**Operational Readiness Clearance (Non-beam operation)
E-961 COUPP – 30L in D0 and MINOS with veto electronics
11/16/2009**

AUTHORIZATION TO PROCEED WITH THE UNATTENDED OPERATION OF E-961 COUPP -30L at
D0 and MINOS including veto electronics

From: Steve Chappa <chappa@fnal.gov>
Subject: RE: COUPP PMT review
Date: November 13, 2009 4:27:28 PM CST
To: 'Mike Crisler' <mike@fnal.gov>, 'bellanto' <bellanto@fnal.gov>
Cc: 'Erik Ramberg' <ramberg@fnal.gov>, 'Russ Rucinski' <rucinski@fnal.gov>, jeter@fnal.gov, sonnenschein@fnal.gov, 'Aria Meyhoefer' <aria@fnal.gov>, hansen@fnal.gov

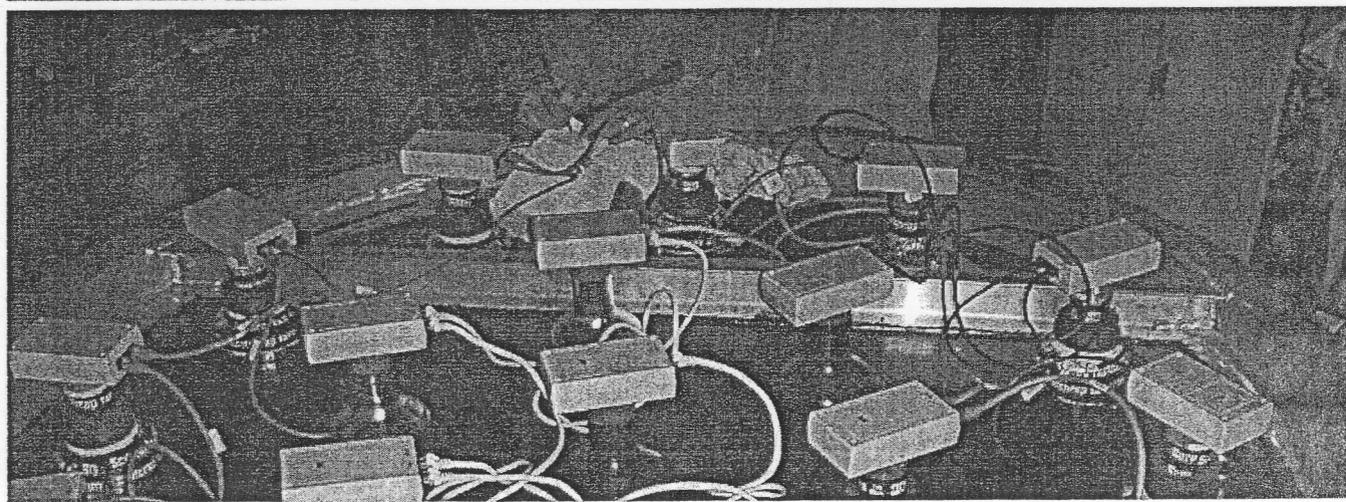
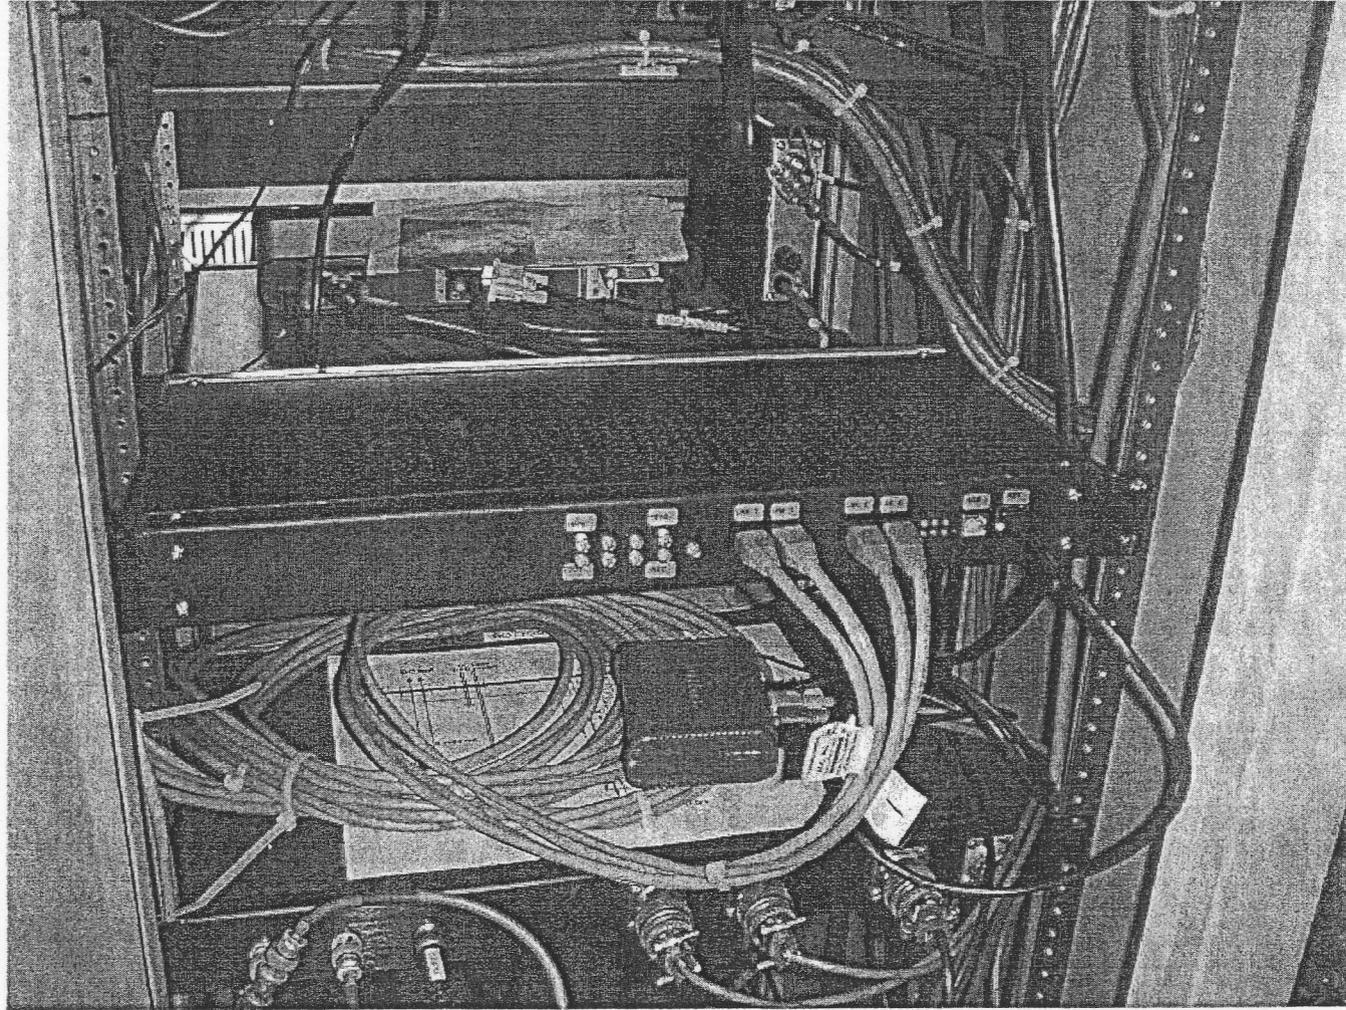
1) Cabling running down the tank to the controls/DAQ rack are run inside a plastic raceway and then protected by trip plates on the floor. No trip hazards seen or potential damage to the cables seen. –OK

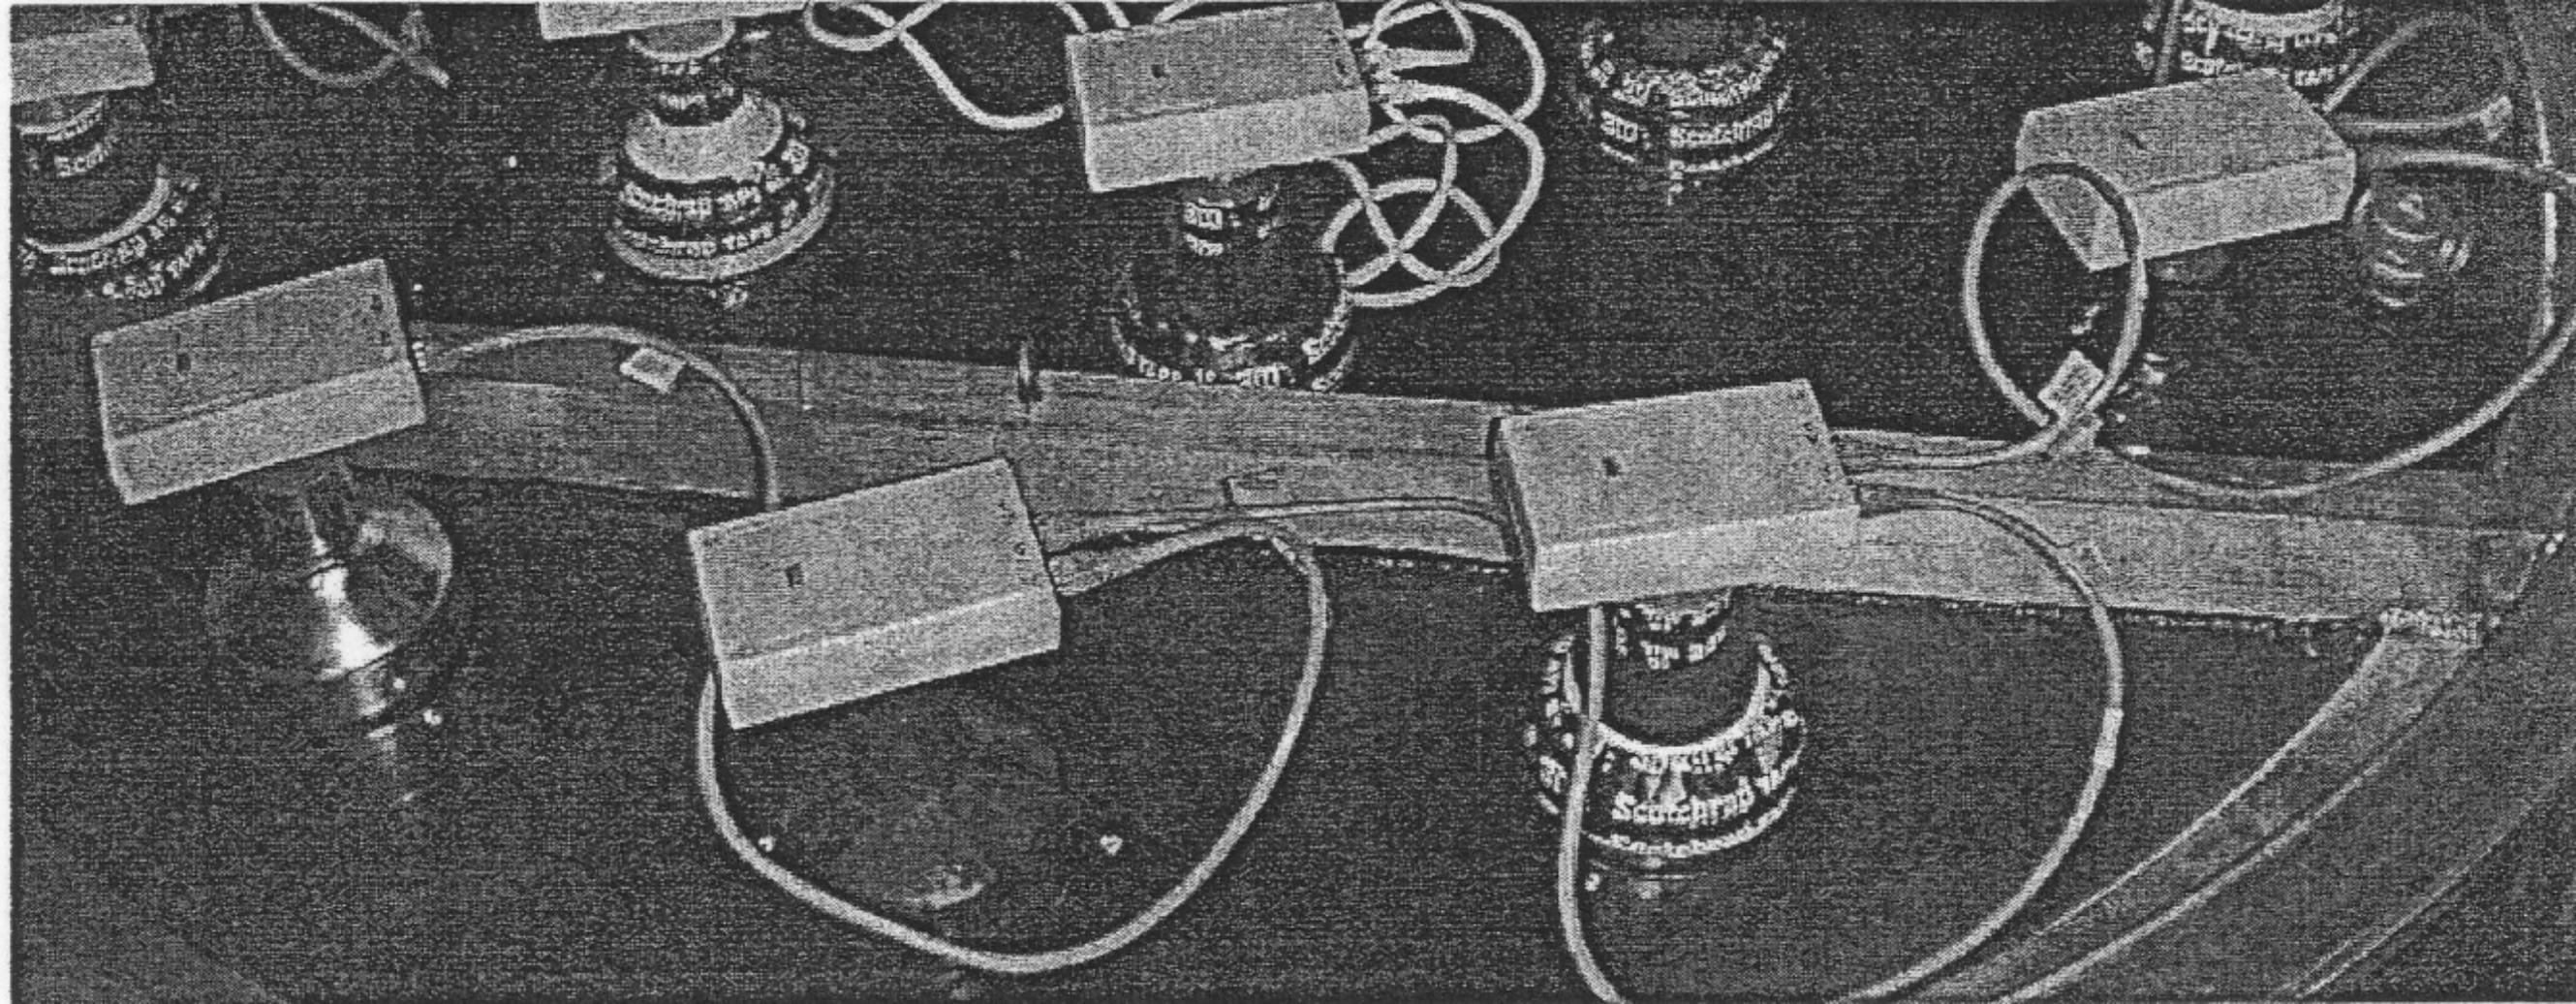
2) A bundle of cables inside the controls/DAQ rack are supported solely by a circular connector connected to the rear of the bottom COUPP CTIC chassis. This bundle of cables need to be supported by strain-relief so as to take the weight and stress off of this connector. This correction was completed during the review. –OK

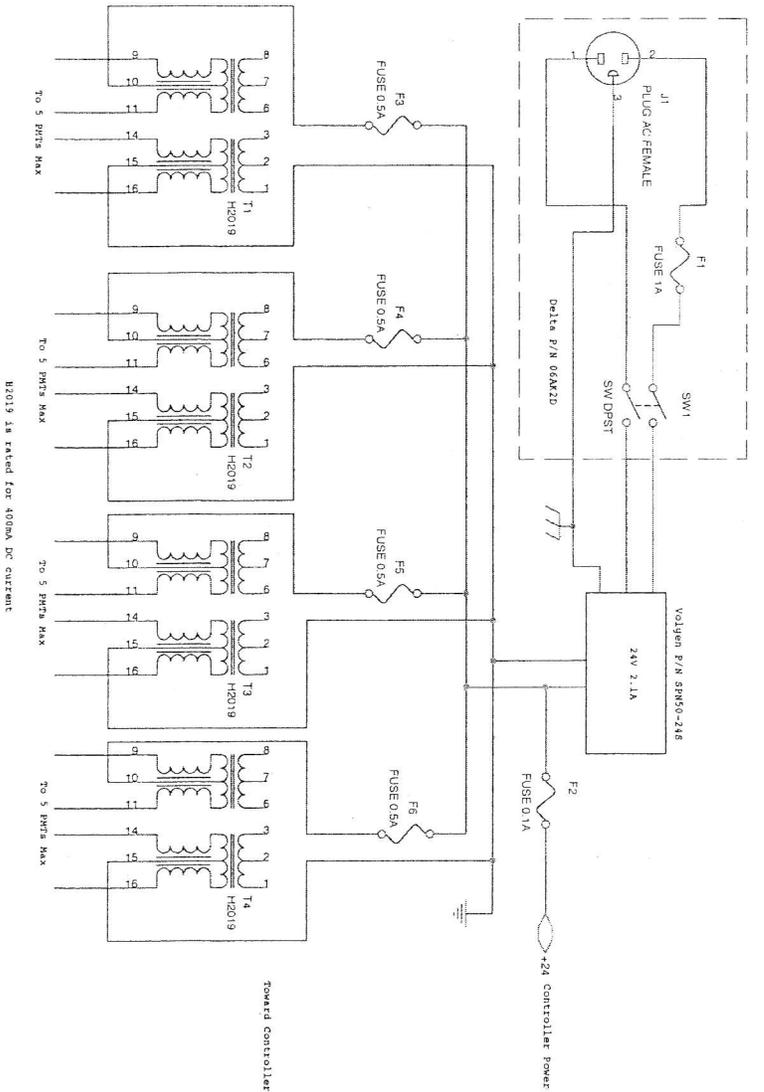
3) Cabling on top of tank exhibited no apparent problems. No AC power located there. –OK
